RE: 2 Lot Partition; Burchill Partition
Case File Number: PAR 16-0001, Burchill
Response for additional information for completeness of application

Burchill Partition

Land Use Application

Drawing Name: s:\2312-020\161\Engr\CAD\Draw\Production\LU\2312-20 P600.dwg Apr 05, 2016 - 1:50pm - cmh

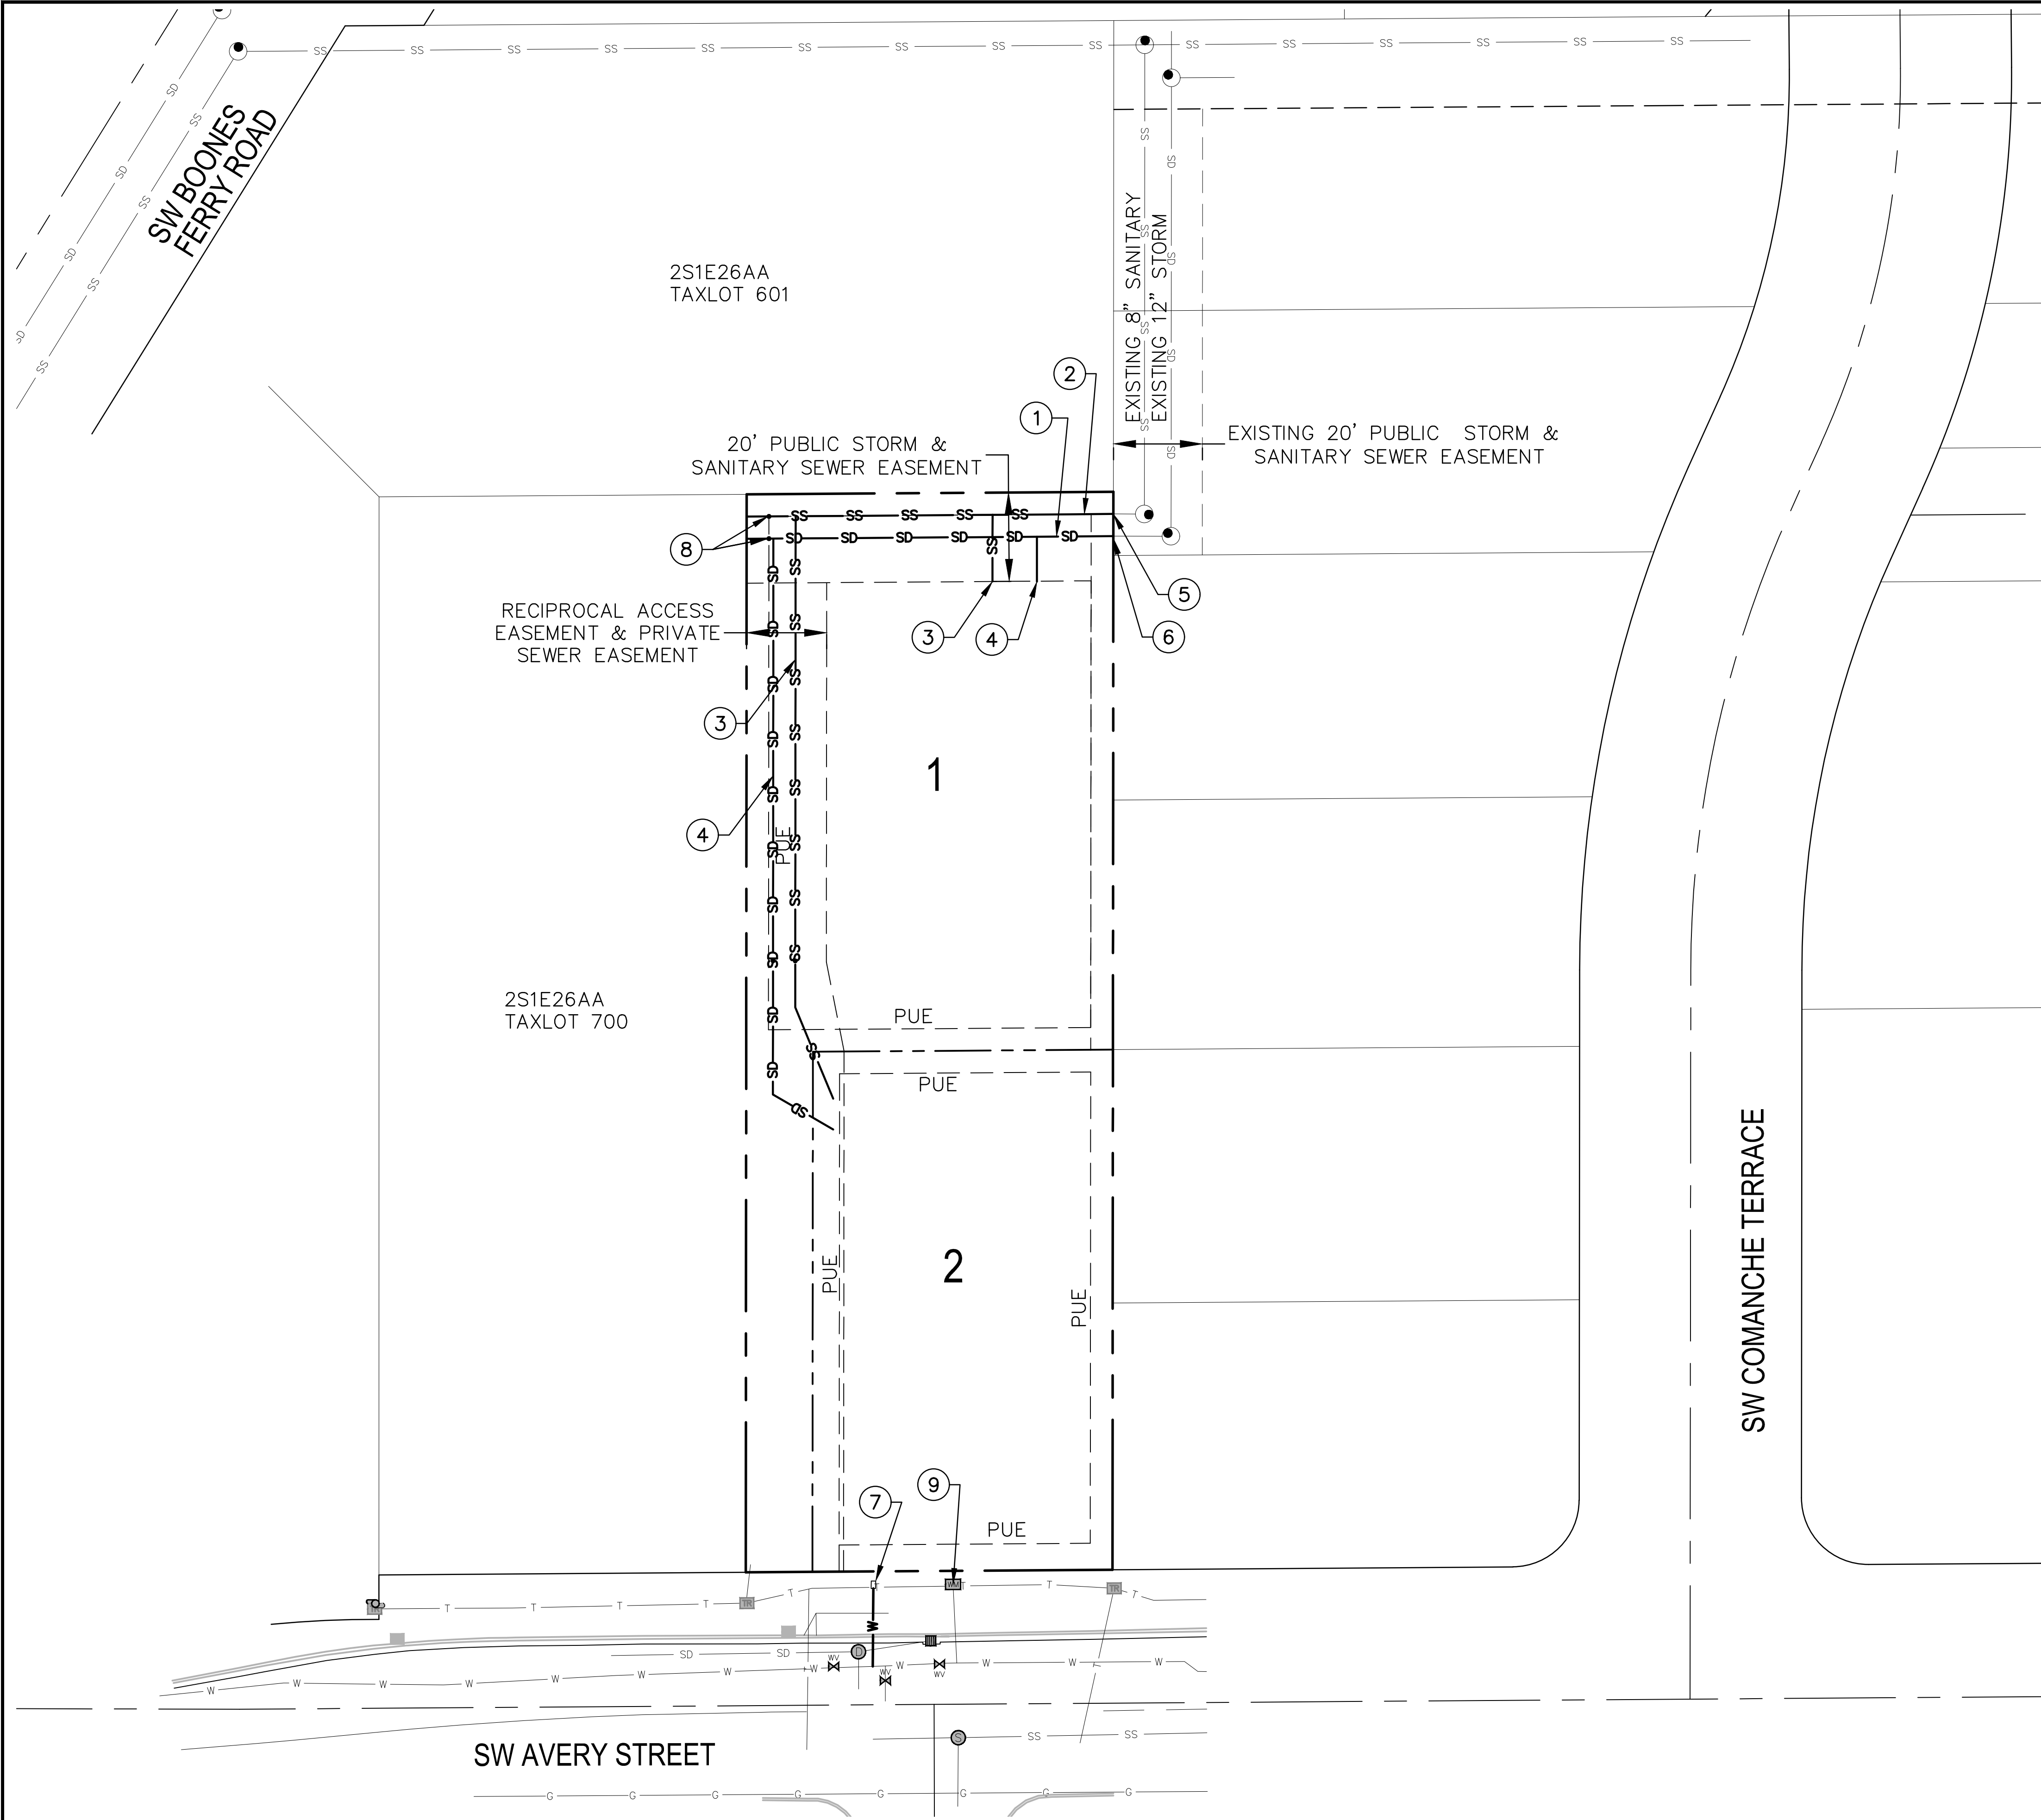
Public lines need to be constructed at the time of development to serve adjacent lots. The proposed plan for the lot to the west to obtain service in the future doesn't satisfy TDC 74.620(3) & 630(3). Revised plans are needed that show:

- *The public sanitary sewer and stormwater lines extending from the property east of this development across the north property line in a 20-foot wide easement to the property to the west*
- *Manholes at the northwest corner of the lot with public lines to the west property line*
- *A 15-foot wide maintenance easement with 12-foot wide surface to the manholes (Operations was willing to not require a turn-around despite the length as it would consume too much property and the line would only be cleaned every three years.)*
- *Revise Grading & Tree Plan to identify tree preservation/ removal in accordance with TDC 73.250(2).*

A fee in lieu will not be possible for stormwater treatment therefore you proposed LIDA systems per lot will be required. Preliminary stormwater calculations including

conveyance are needed to demonstrate that gravity service can be provided and appropriate detention can be constructed (that the lines do not need upsizing).

Response: An updated plan set, narrative, and stormwater report are enclosed with this submittal. The public sanitary sewer and stormwater lines have been shown on the plan set with an extension to the western property line in a 20-foot easement. The shared access drive extends to the 20-foot easement via a 12-foot surface one a 17-foot maintenance easement. The grading and tree plan identifies the trees that will be removed for the subdivision. An arborist report is included with this submittal.

Response: The Applicant has submitted a Utility Plan drawing (See Sheet P600 in Exhibit B) showing how storm drainage lines will be installed to serve the proposed lots. Detailed plans will be submitted for review and approval prior to construction. The applicant will construct LIDA facilities for the 2 lots for treatment. The systems will be connected to the new stormwater main extension at the north end of Lot 1 as shown on the utilities plan.
